N5224A-01A

**S E R V I C E N O T E**

Supersedes:  
N5224A-01

N5224A PNA Series Microwave Network Analyzers

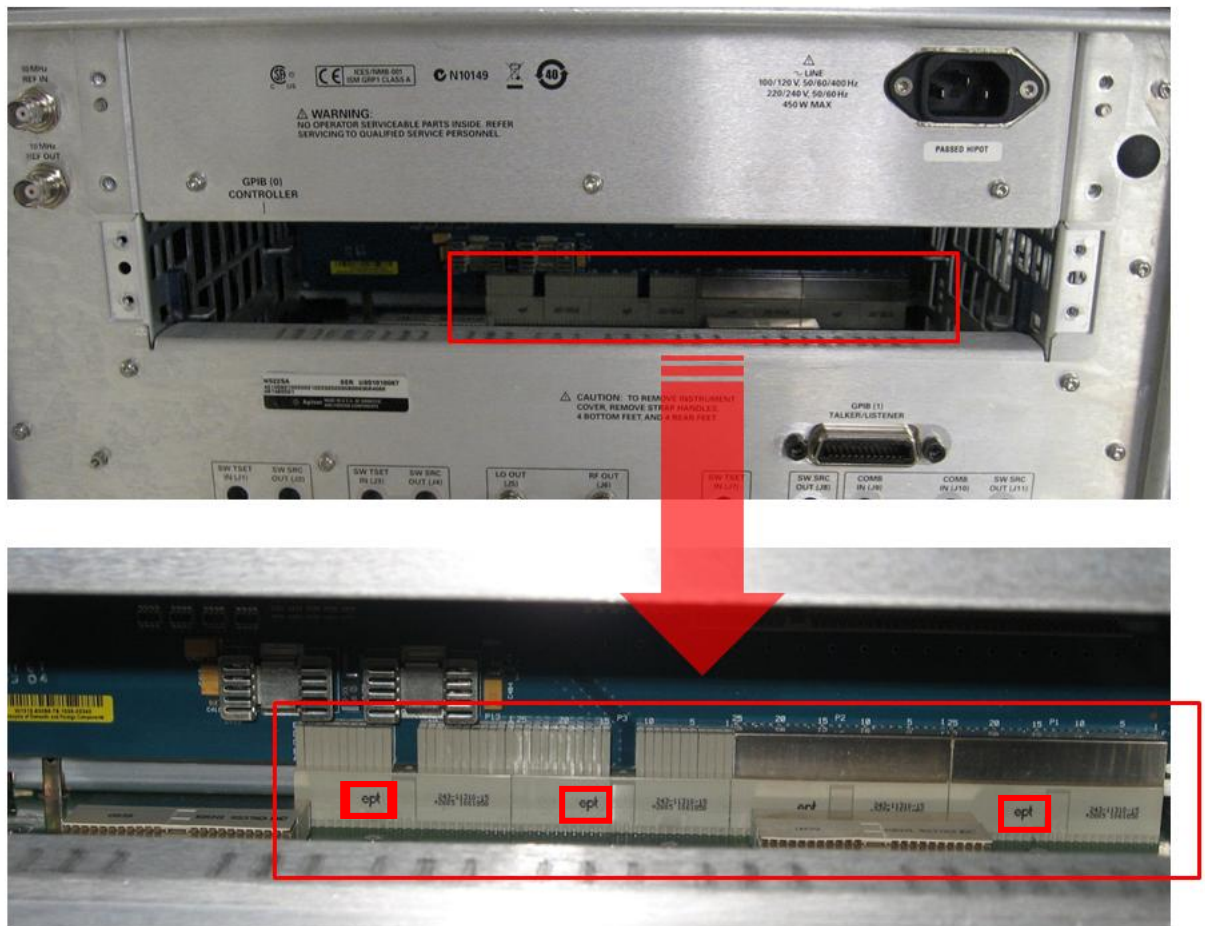
1. Remove the CPU assembly from the analyzer's rear panel. Refer to the PNA Service Guide chapter 7 section titled, "Removing and Replacing the CPU Board Assembly" for removal and reinstallation procedures. To view the online Service Guide, see the numbered list on the next page for instructions.
2. As per the photo below, inspect the system motherboard connector to see if it has one or more "ept" logos.

3. If the connector has one or more “ept” logos, return the analyzer to Agilent for replacement of the system motherboard. If the connector does not have one or more “ept” logos, email [ctd-soco\\_support@agilent.com](mailto:ctd-soco_support@agilent.com), providing the analyzer model and serial number and details of the malfunction symptoms.
